PD Modification Application: PRS 23-0373

BOCC Land Use Meeting Date: June 13, 2023

1.0 APPLICATION SUMMARY

Applicant: Kami Corbett, Hill Ward Henderson

2.5 Proposed Site Plan (partial provided below for size and orientation purposes. See Section 8.2 for full site plan)

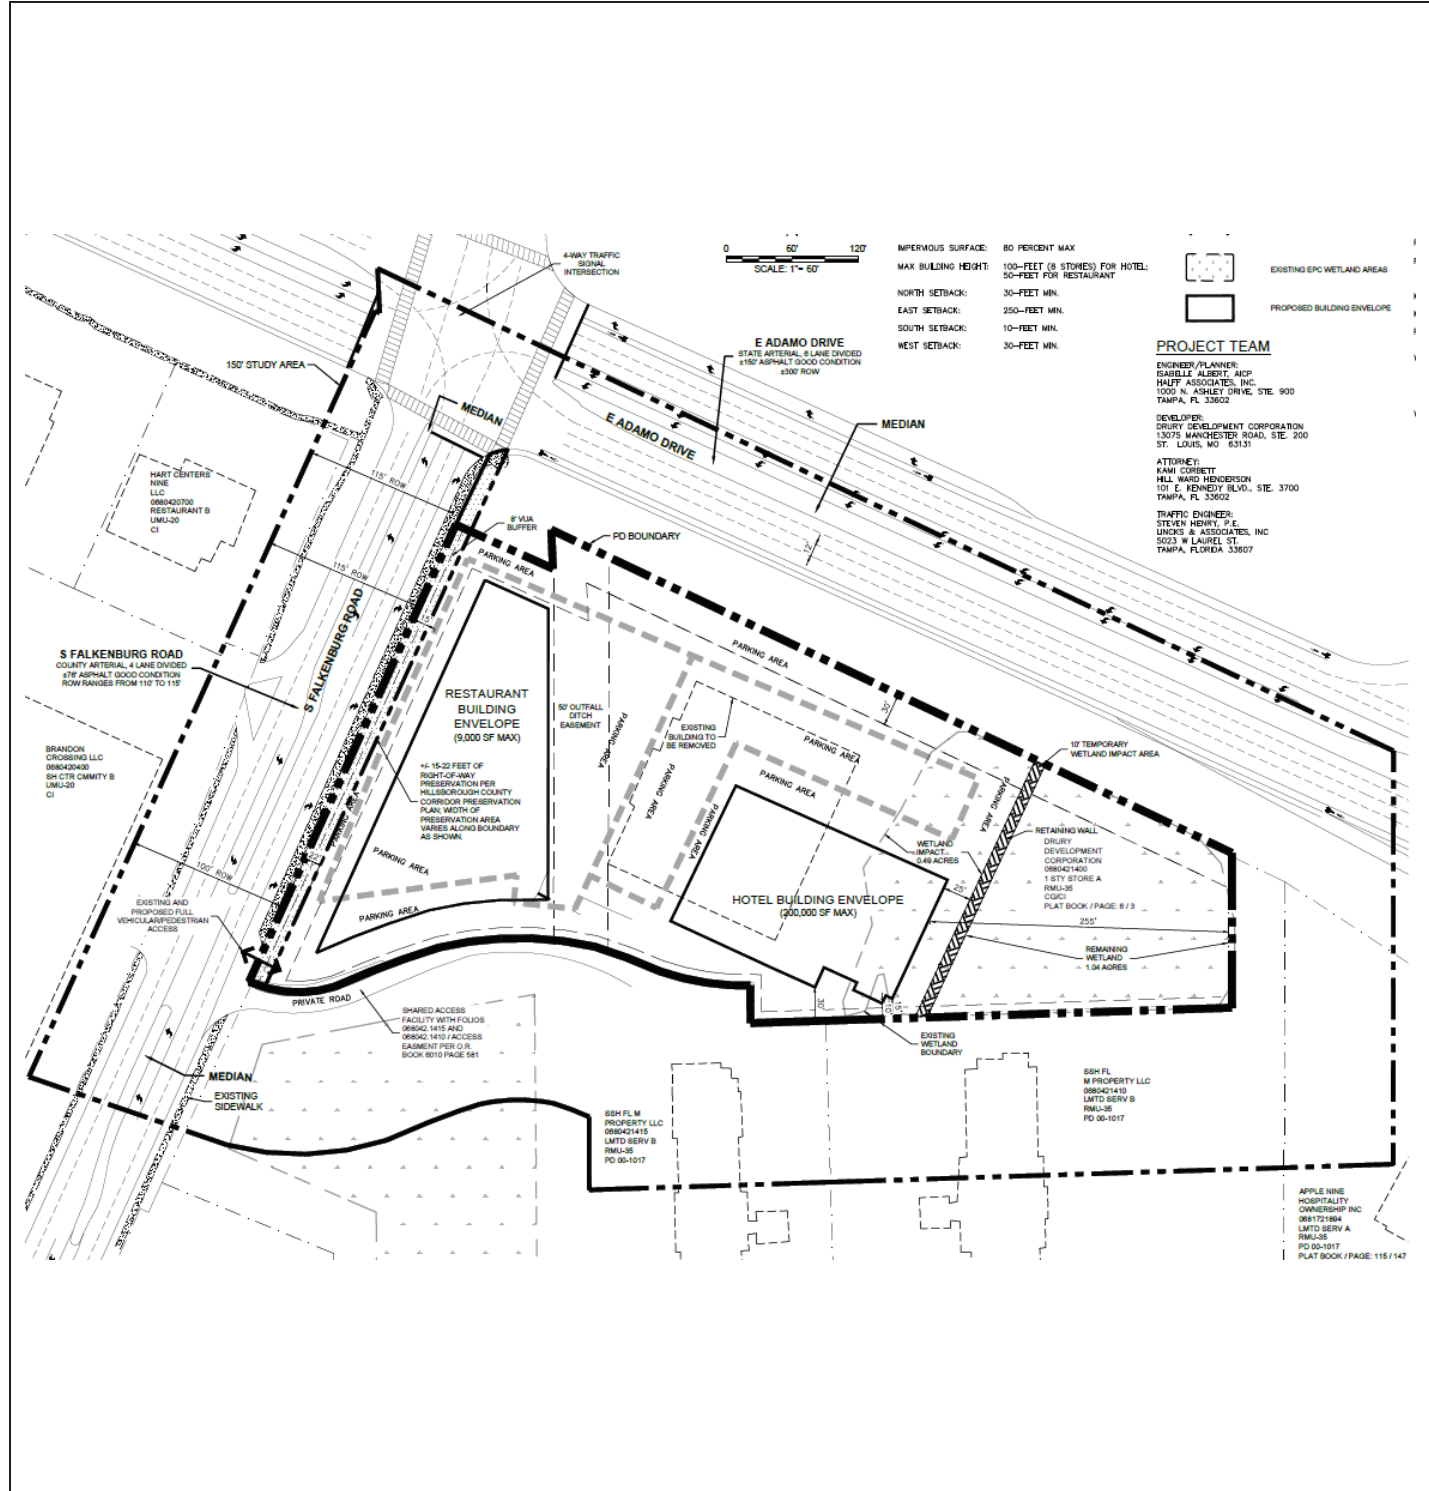
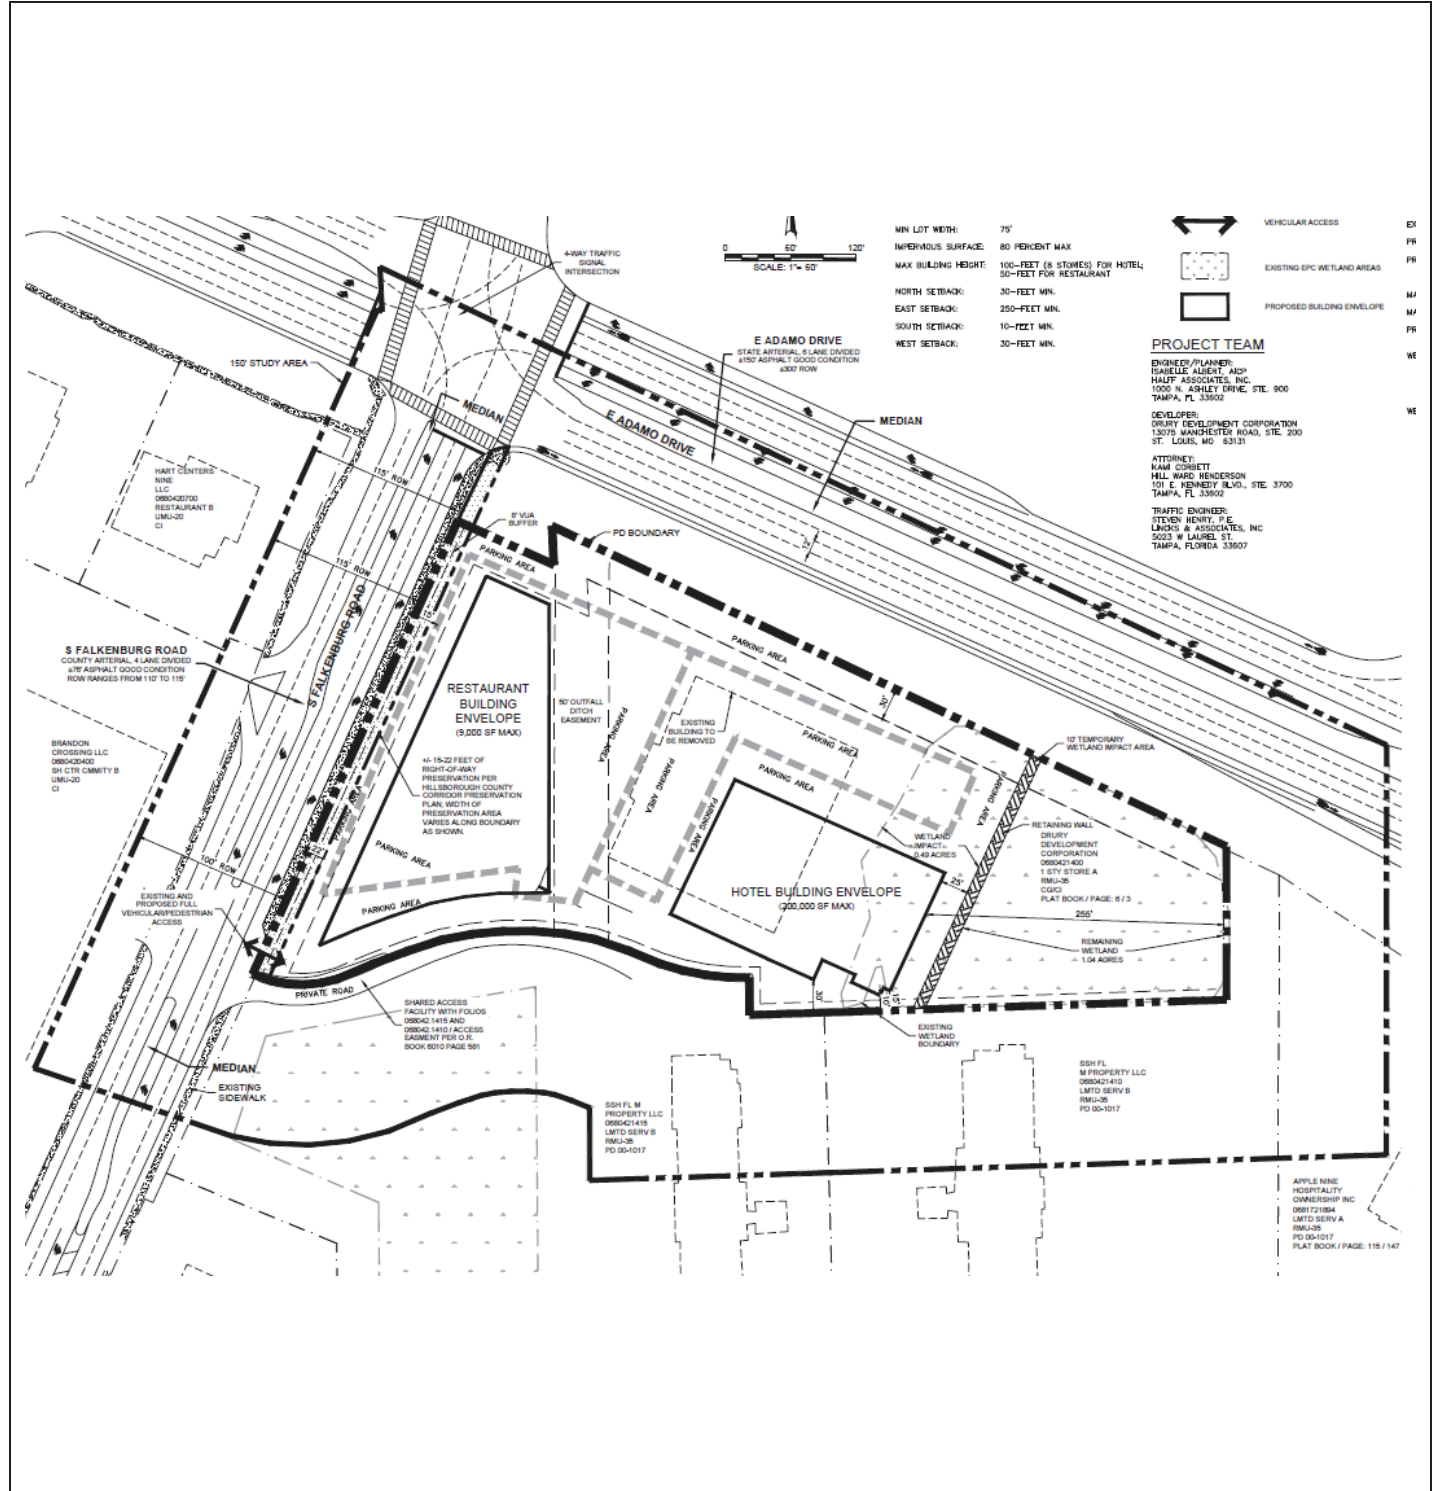
Allow the location of a Vehicular Use Area (VUA) and required buffer area as an interim use of the S Falkenburg Road right-of-way preservation area. Remove the Vehicular Use Area buffer requirement at the time the right-of-way preservation area is utilized.

Memorialize the approved 260 parking spaces described in the PD 22-1226 approved site plan.

Pursuant to LDC section 6.06.04.C an 8-foot landscape buffer is required between the vehicle use area (i.e. parking) and right-of-way. Pursuant to LDC Section 5.11.09.A.1, said buffer can be provided in a required right-of-way preservation area provided it is relocated upon utilization of the right-of-way. The right-of-way preservation area along Falkenburg Road varies from 15-22'. The parcel is located at the southeast corner of the intersection of Falkenburg Road and SR 60A, which is an improved intersection with a right turn lane and sidewalk running the length of the property frontage. For the existing use of the site an open space buffer is located within the right-of-way preservation area. Staff concurs with the applicant’s justification for the requested variation to not require relocation of the buffer in the future when the right-of-way may be utilized for future improvements to Falkenburg Road. As noted in the applicant’s justification statement, the irregular shape of the parcel with environmental constraints along the eastern portion of the parcel create development constraints for future relocation of the buffer under the approved zoning development plan. Furthermore, the interim use of the right-of-way preservation area for the landscape buffer would be consistent with the existing site configuration and provide for enhanced landscaping where none presently exists.

The applicant submitted a variation to LDC section 5.11.09 as it pertains to the inclusion of the required LDC 6.06.04 VUA buffer in a ROW preservation area. The requested variation requests to locate the Vehicle Use Area buffer within the right of way preservation area without the need to relocate at the time the right of way area is utilized for the future planned widening of Falkenburg Road. The approved PD

requires up to 22 feet of right of way to be preserved along Falkenburg Road for the future planned widening of Falkenburg Road to a 6-lane roadway. The applicant indicated that based on the variable existing right of way along Falkenburg and the outfall ditch easement location on site, the Vehicle Use Area must be placed in the preservation area in order to develop the property as approved. Transportation Staff has reviewed the proposed variation and does not object.

3. Buffering and screening shall be in accordance with LDC 6.06.06 buffer and screening provisions-, except that the required vehicle use area buffer per LDC 6.06.04 on the western boundary shall be permitted to be located within the right-of-way preservation area in accordance with LDC 5.11.09, but shall not be required to be relocated elsewhere on the site at the time the right-of-way preservation area is utilized.

5. The vehicular parking ratio for the hotel shall be 0.83 spaces per hotel room. The minimum total number of required vehicle parking spaces at build-out of the project shall be 260 spaces. The Hotel and Restaurant uses may be constructed in phases, therefore, the vehicular parking ratio for the Hotel shall be 0.83 spaces per hotel room until such time as both the Hotel and Restaurant uses are constructed, subject to the additional provision of 11 bicycle parking spaces consistent with LDC, Sec. 6.05.02. P.
